This letter confirms our telephone conversation of this date regarding categories and possession limits of Radioactive Materials for License No. 06-00217-06.

Subject: Response To Questions On Renewal Application

COMBUSTION ENGINEERING, INC.
Broad Scope Radioactive Materials
License Renewal Application
Responses To NRC Questions

Figure 7.1-1
Organization Chart

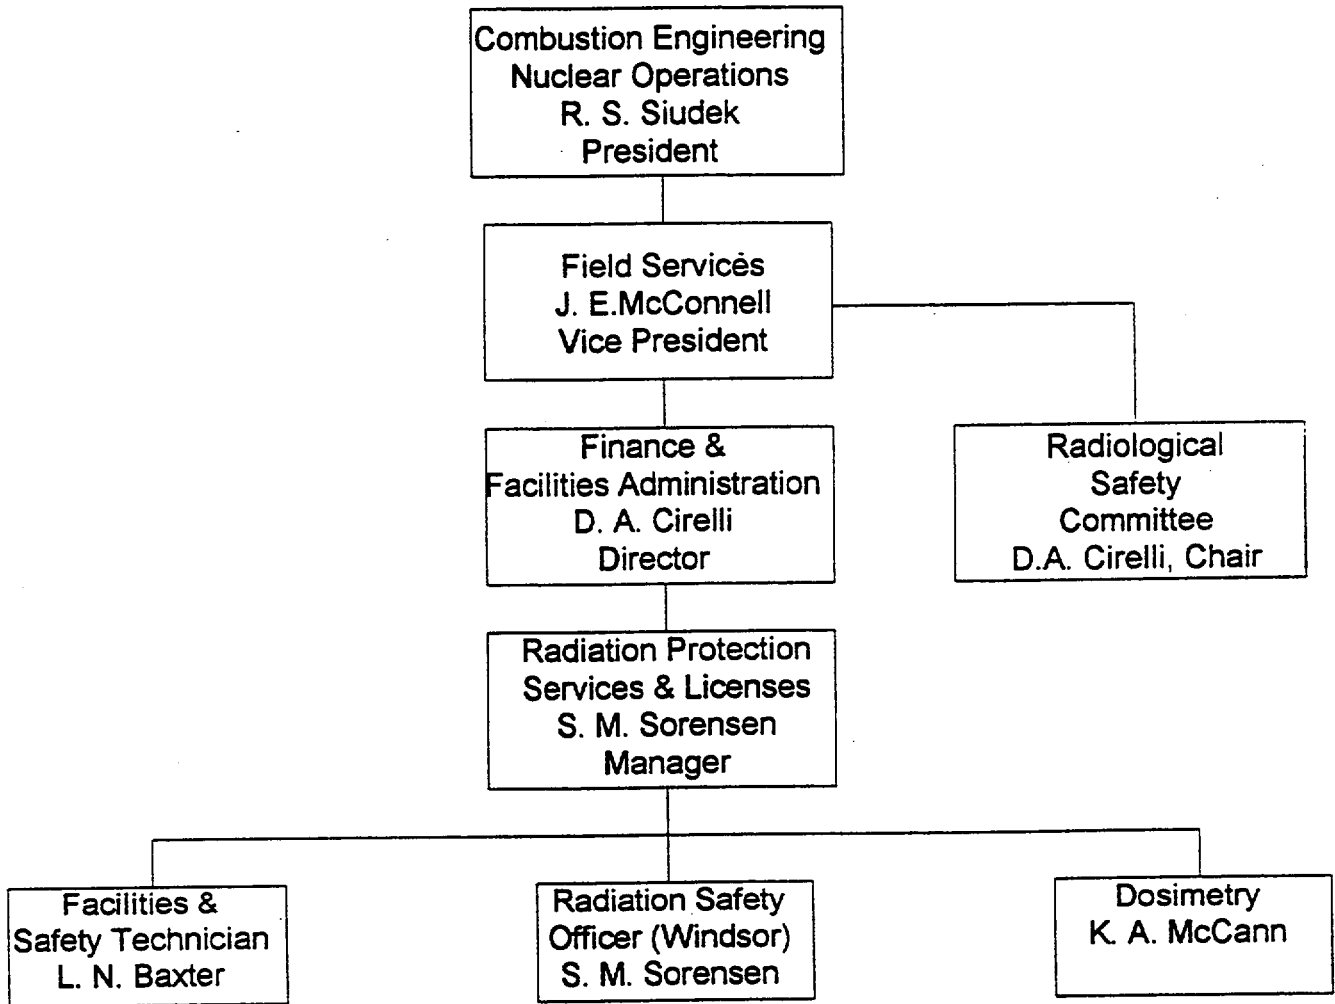
Figure 7.1.1 in your application shows the organizational structure of personnel involved with radiation safety. This figure does not include the RSC. Please revise this figure showing the organizational relationship of the RSC to senior management.

Figure 7.1.1 has been revised to show the reporting relationship of the RSC to senior management. Enclosure (4) contains the change page with the revised figure.

Figure 10.7-6A
Locations of Site Boundary Environmental TLDs

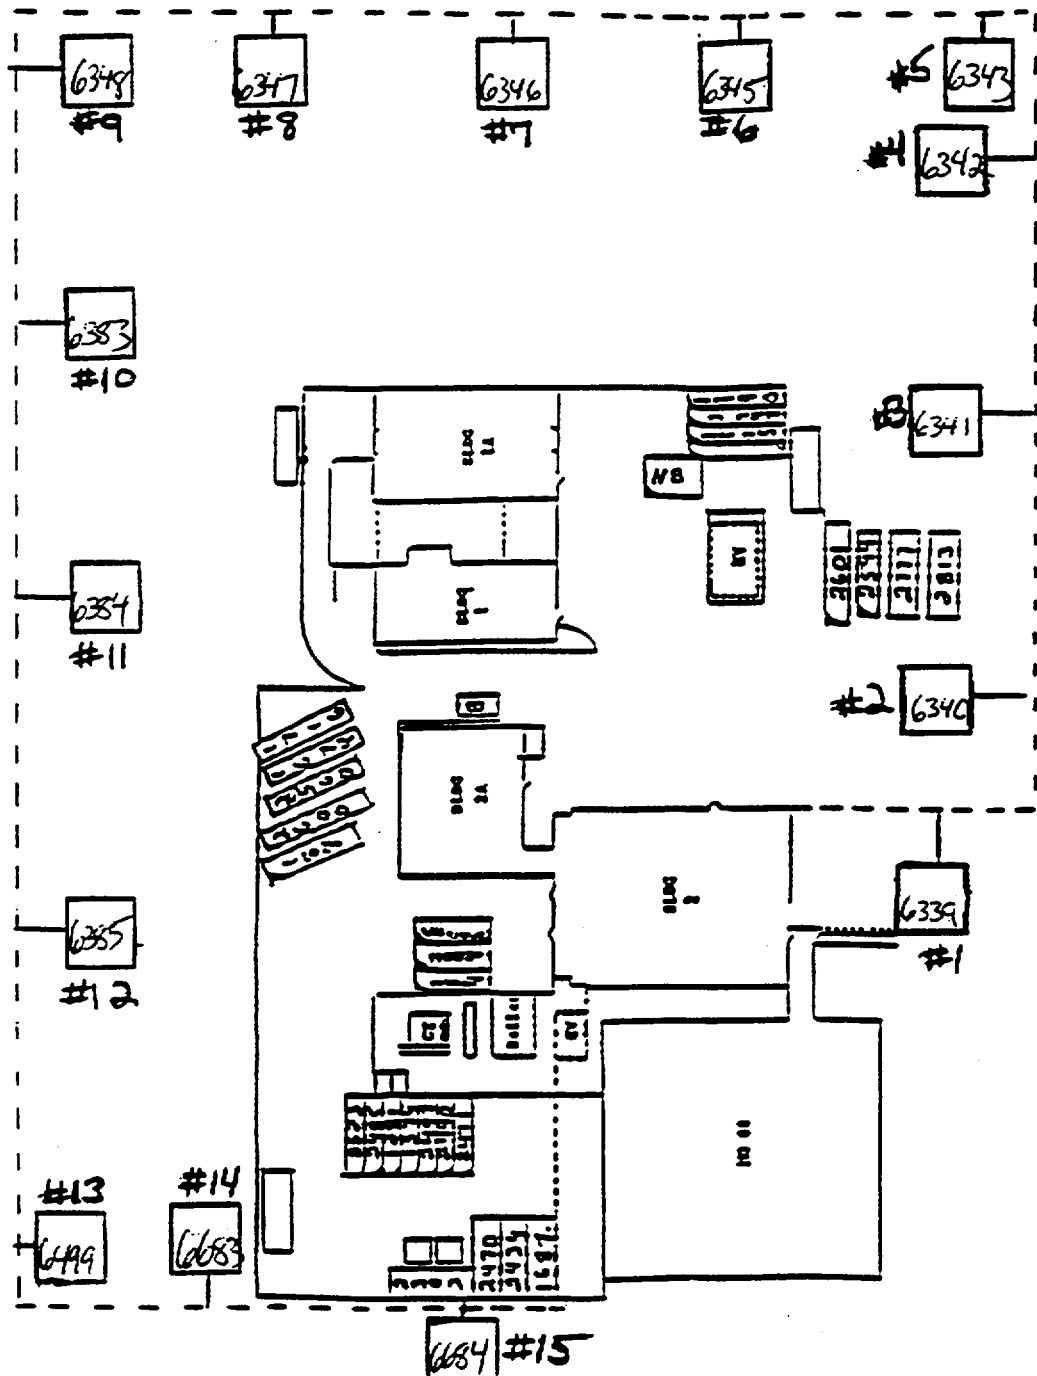
10 CFR 20.1302(b) requires that the licensee show compliance with the annual dose limits in 10 CFR 20.1301. Describe your procedure for demonstrating compliance with 10 CFR 20.1301. If your procedure uses calculations or use of pathway models, please provide sample calculations or the name(s) of specific references or models utilized.

Compliance with 10 CFR 20.1302(b) is demonstrated through the use of boundary TLD's in accordance with RPI-7 and through effluent air calculations performed in accordance with NESHAP's calculational model. Statements to this effect have been added to revise Section 10.7.1 on page 60a and a sample compliance report to satisfy the EPA has been added as Figure 10.7-5 of the application. Enclosure (4) contains change pages with the text revision and the added figure.
